NTS 02-G & NTS 03-G+ Firmware Release Notes

VERSION 3.21r7 (May 2018)

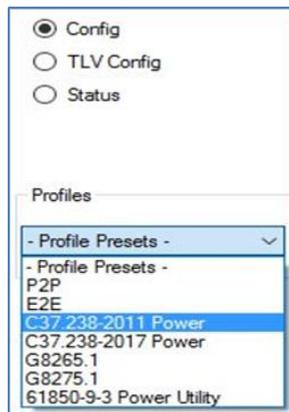
- **Improvement:** While configuring NTP multicast address, if the IPv4 address assigned for multicast is an invalid address, then the clock will use the broadcast MAC address. For valid IPv4 multicast addresses a valid multicast MAC will still be used.
- **Improvement:** Clocks getting their Sync from IRIG-B or PTP will advertise Stratum-1. Previously they were advertised as Stratum-2
- **Improvement:** Added ability to lockout a user for a period following several unsuccessful login attempts. Both the number of unsuccessful attempts and the period of lockout can be configured.

System Policy

Login attempts before lockout

Lockout Period Seconds

Minimum password length

Password must contain n groups* of 4

Don't allow username in password

Two passwords

By default, this feature is disabled (Logging attempts before lockout set to 0) and this will be the case for clocks upgraded to this version.

To prevent the leaking of security information there is no notification to a user that the lockout is in place, and the standard login failed message will be displayed.

The lockout is based on the user account and operates regardless of the IP address that the attempt is made from or if the attempt is made via SNMP or the Config Tool. Similarly, a failed login via any method or from any address adds to the users failed login attempts count.

The lockout is per account and a lockout on one account does not prevent other accounts from logging in.

Subsequent incorrect login attempts during the lockout period will not increase that period. SNMPv3 traps authenticated with the credentials of a locked-out user will still be sent.

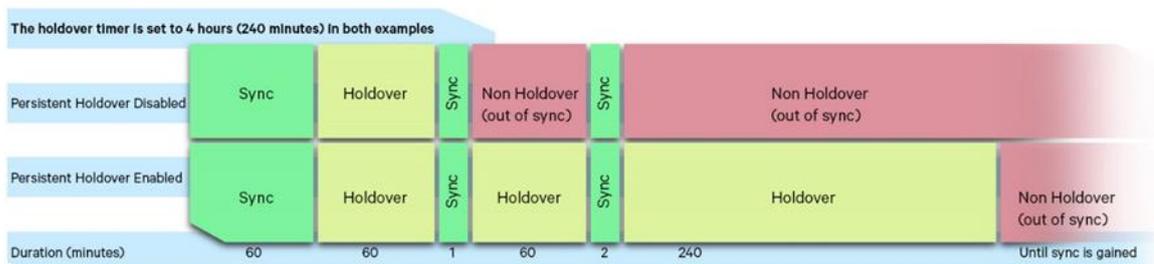
- **Feature:** Added support for enabling the persistent holdover availability option. Tekron Configuration Tool 4.2.1.10 or later is required to enable this option.

Normally, the clock can only enter holdover if it has been in sync for at least 5 minutes. If persistent holdover is enabled, and the clock has initially been in sync for at least 5 minutes, then the clock can still enter holdover if it experiences a sync switching condition. For example, sync is lost, regained for less than 5 minutes, then lost again. Such a condition may exist when GNSS jamming is present, or in the case of a poor antenna installation.

Please note, when entering holdover after a period of intermittent sync the holdover period timer is reset. This may cause the clock to enter into an extended holdover period, if the sync switching condition continues to be present. By disabling persistent holdover, you can ensure that the time in holdover is not extended by periods of intermittent sync lasting less than 5
